PROPOSED ARHSEPP RFB
@ 13-15 NICHOLAS AVE CAMPSIE
FOR CIVECO PTY LTD
S4.56 MODIFICATION

drawing: ROOF / SITE ANALYSIS PLAN	project: PROPOSED ARHSEPP RFB @ 13-15 NICHOLAS AVE CAMPSIE	client: CIVECO PTY LTD	drawn: J.S.	scale: as shown	sheet size: A3	Council
			checked: J.E.	date: DEC	ref: 2022-1558	CBCC

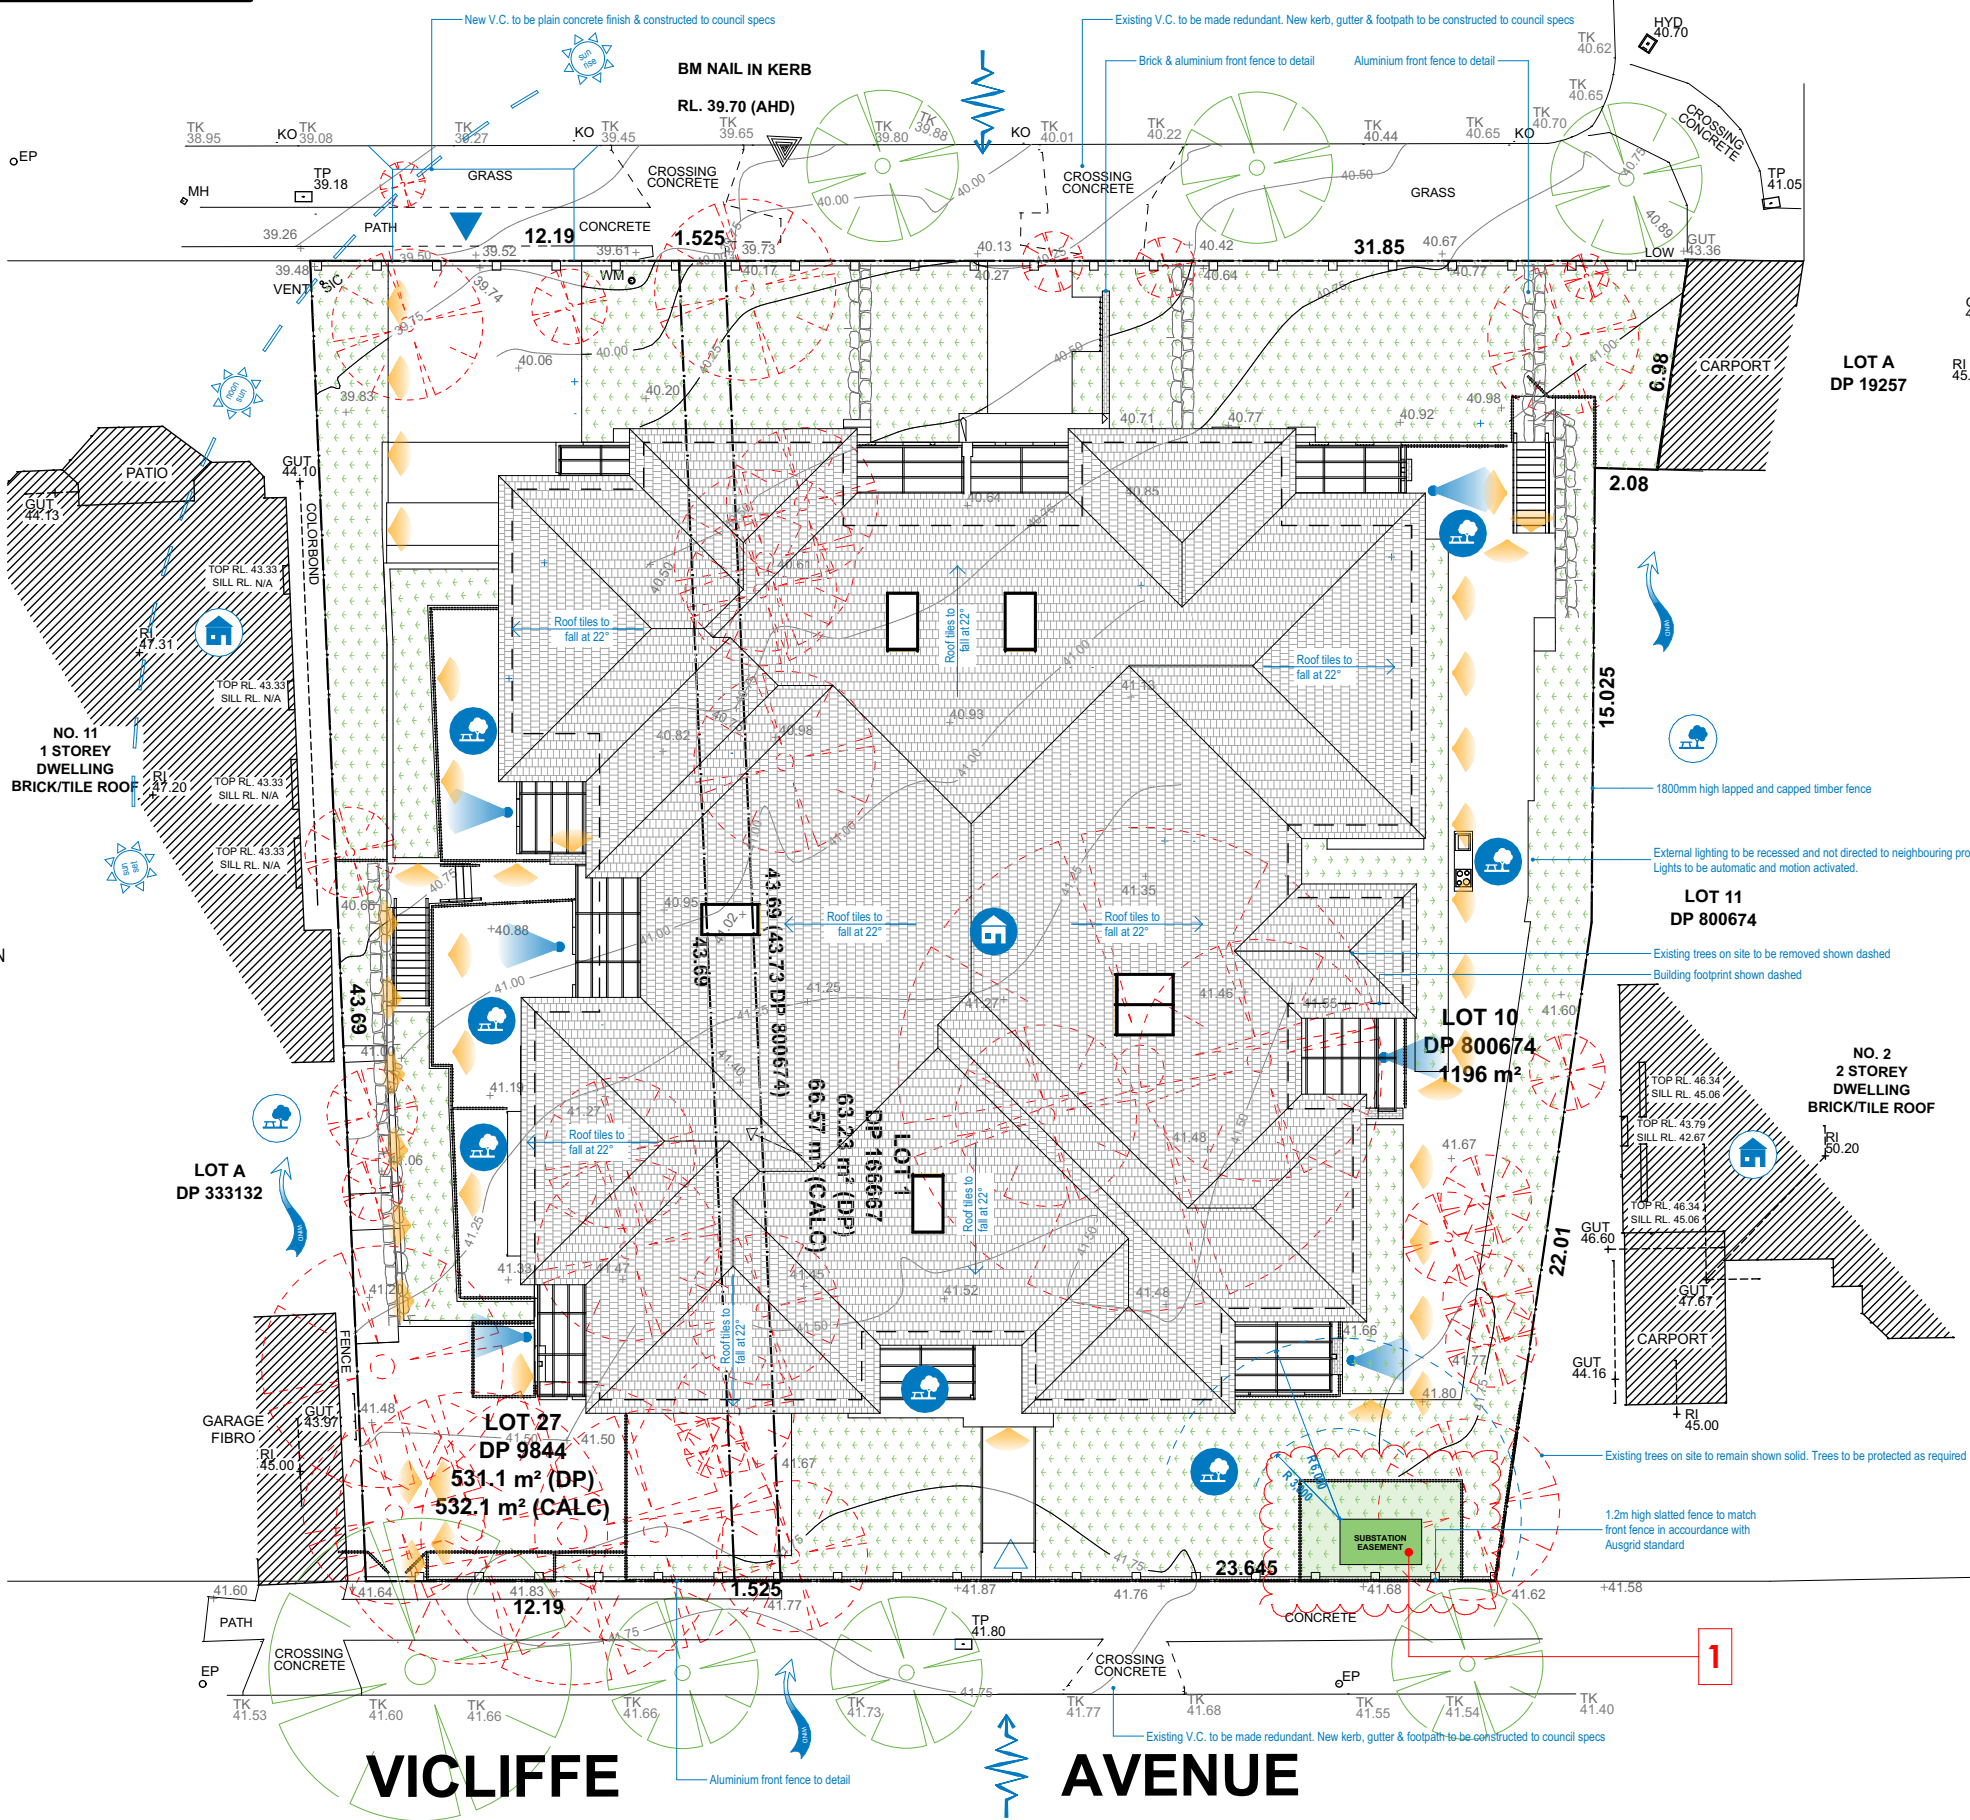
1. INTRODUCTION OF SUBSTATION
ALONG VICLIFFE AVE FRONTAGE

drawing:	GROUND FLOOR PLAN
project:	PROPOSED ARHSEPP RFB @ 13-15
client:	NICHOLAS AVE CAMPSIE
client:	CIVECO PTY LTD
drawn:	J.S.
checked:	J.E.
scale:	as shown
date:	DEC
sheet size:	A3
ref:	2022-155B
Council	CBCC

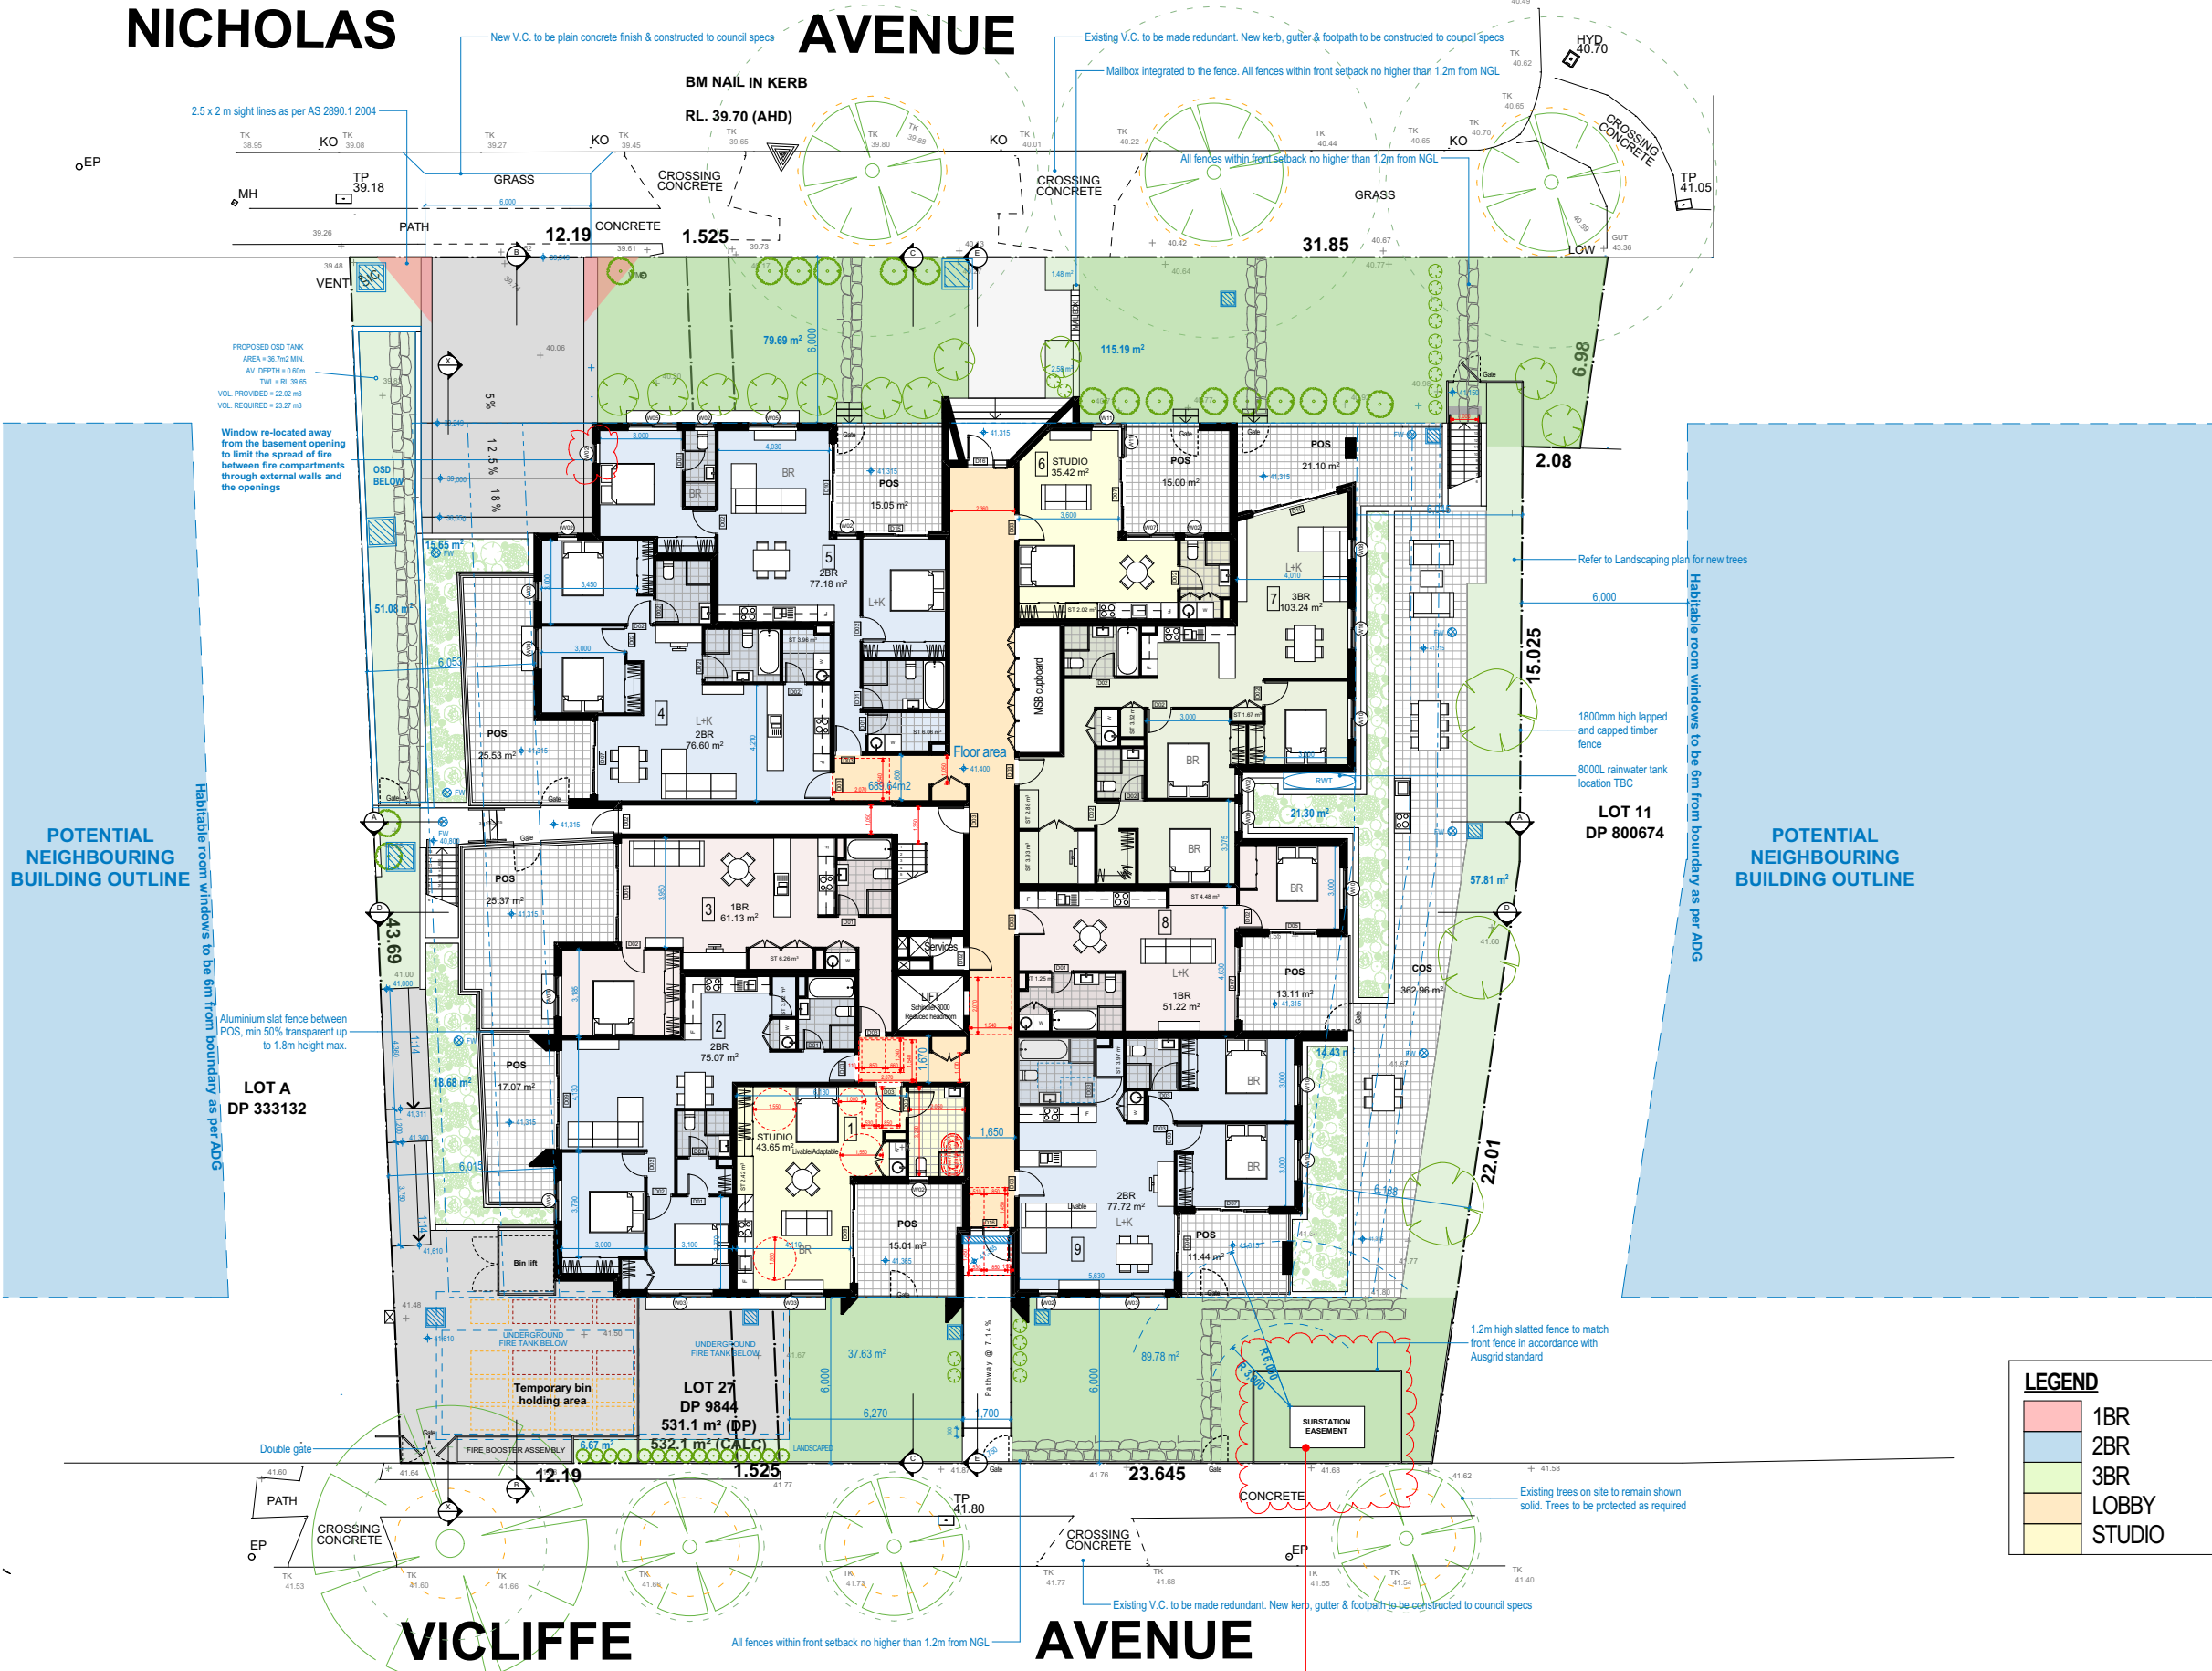
1. INTRODUCTION OF SUBSTATION
ALONG VICLIFFE AVE FRONTAGE
